CITY OF PORTLAND, MAINE Department of Building Inspection

LOCATION 6779 Forest Ave.

A.P.- 779 Fore & Avonue

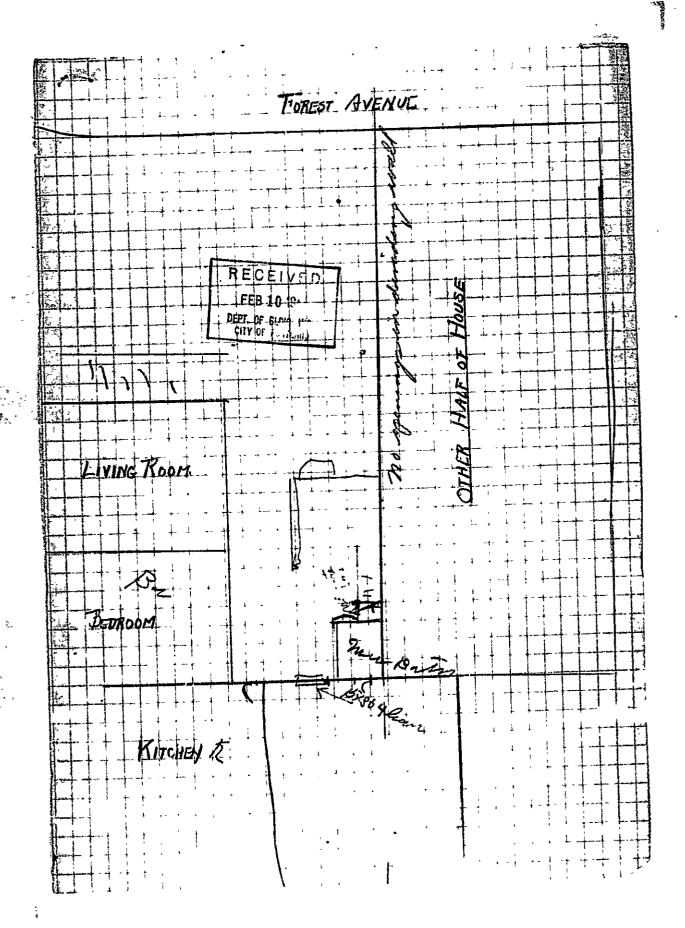
There is not enough information for us to check compliance with the Building Code.

As you will see from Section 203f of the Building Code (revised copies of the Code available for examination at this office or available to possess one at the City Clerk's Office), the question of cellarways and material for finishing partitions in gublic ballways of apartment houses is important.

Fig. any record we can discover in City Hall, the established use of the building is for three aparticute or families. This application indicates that there are nonfourillies in the building and that the same number would be recorded after the alterations. Will the owner be kind enough to told us in writing when this fourth sparticul was established and by a plan or exacts to scale show where the fourth aparticult is located as to whether first, second or third floor and where abouts on that floor? Also would of the balance of the building so that we say tell what effect the fourth apartment has or may have on the balance of the building under Suilding Gods requirements.

Also owner or contractor should furnish a skotch to scale showing the location of the proposed alterations with relation to the balance of the first floor. Probably one plan if made accurately to include enough area and crough floors and if made to scale will answer all of our questions.

A thotograin which I have found of the building leads me to tolive that remaps this is a duplex house with a contral partition running clear through it. If that should turn but to be the case, it is important for the owner to show on plan or in some manner whether or not one can no from one side to the other of the building or on any floor or in the cellar without going out-of-doors.

Until we have enough information in understandable fashion to check against Building Code requirements, the permit cannot be issued and of course the work should not be stated.
